# Access Compliance Report

### (Curb Ramps)

Intersection ID: 47107	Main Street: ERNEST_RUSSELL_CT	Cross Street: HATTIE_LITTLE_ST	Location: SE
ADA ID: 82442A111ED0	Ramp Type: PerpDiag	Initial Pass/Fail: Fail	Overall Compliance: No
Severity Score: 21.25			
Codes/Mitigation Info/Possible Solution		Field Measurements/Component Compliance

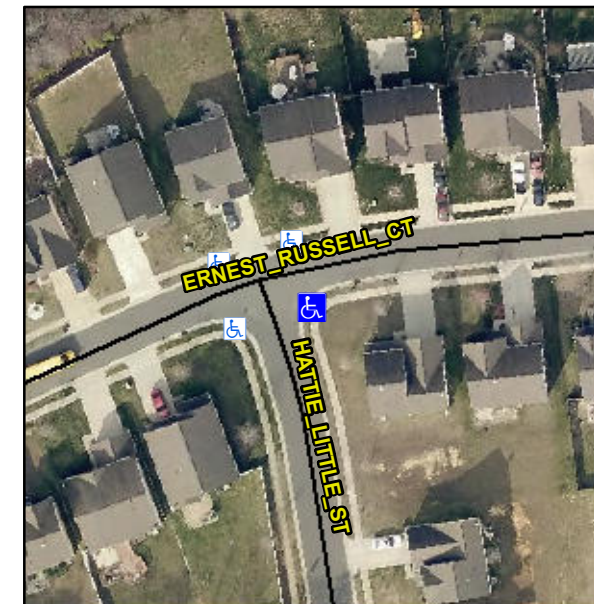
Compliance	Description	Data	Compliance	Description	Data
N/A	Ramp Length (in)	49.0	No	Ramp Slope (%)	10.5
No	Ramp Width (in)	41.0	Yes	Ramp XSlope (%)	1.3
N/A	Flare Type LT	N/A	N/A	Flare Type RT	N/A
N/A	Flare Slope LT (%)	N/A	N/A	Flare Slope RT (%)	N/A
N/A	Flare Traversable LT?	N/A	N/A	Flare Traversable RT?	N/A
N/A	Landing Length (in)	N/A	N/A	DWS Provided?	N/A
N/A	Landing Width (in)	N/A	N/A	DWS Contrast?	N/A
N/A	Landing Slope (%)	N/A	N/A	DWS Length (in)	N/A
N/A	Landing X Slope (%)	N/A	N/A	DWS Full Width?	N/A
N/A	Landing Curb? (Y/N)	N/A	N/A	DWS Offset (in)	N/A
N/A	Shared Landing?	N/A			
N/A	Gutter Ponding?	N/A	N/A	Gutter Slope (%)	N/A
N/A	Gutter Lip Ht (in)	N/A	N/A	Gutter X Slope (%)	N/A
N/A	Painted X Walk1?	No	N/A	Painted X Walk2?	No
	X Walk 1 Direction	To N		X Walk 2 Direction	To W
N/A	X Walk 1 Width (in)	N/A	N/A	X Walk 2 Width (in)	N/A
	X Walk 1 Slope (%)	2.6		X Walk 2 Slope (%)	0.8
	X Walk 1 X Slope (%)	1.6		X Walk 2 X Slope (%)	0.9

**Remove & Replace Curb Ramp With Two New Directional Ramps or Equivalent.**

**R304.5.1, R304.2.2**
